Please follow these steps to upgrade your ZX Diag Cart v2.15.

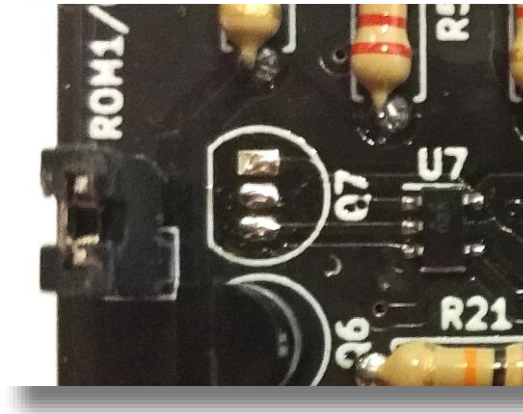
1. Remove Q7.

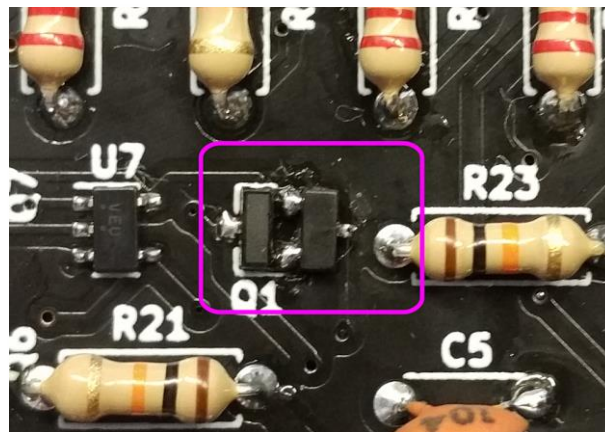
2. Solder the new transistor **upside down** to Q1 - you can solder both joints from the sides. We marked the **top** of BSS84 with silver paint, so you should **not** see that.

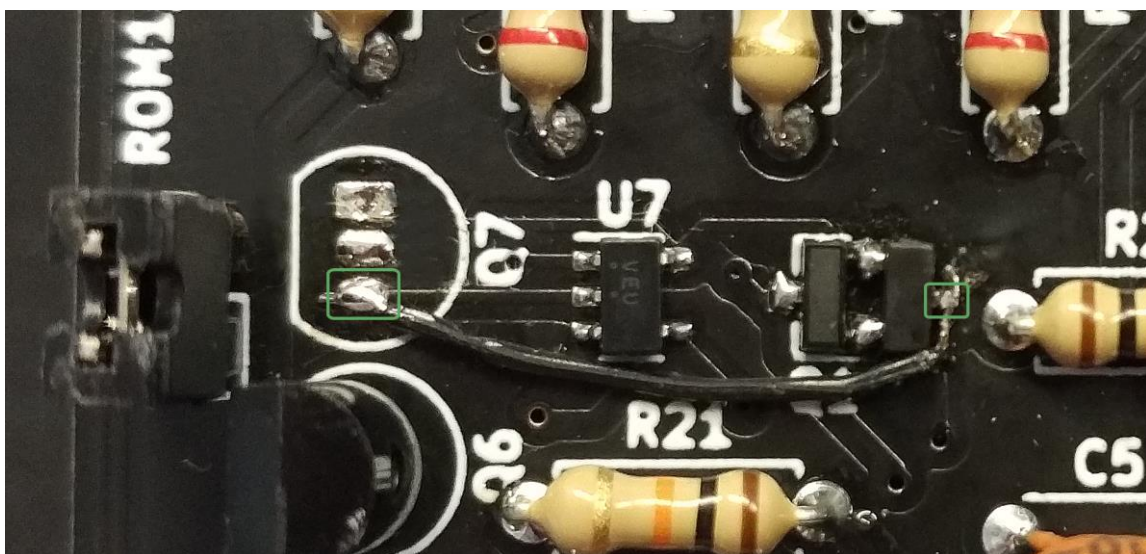
3. Add a wire from the third pin of the new transistor, to the lowest pad of Q7.
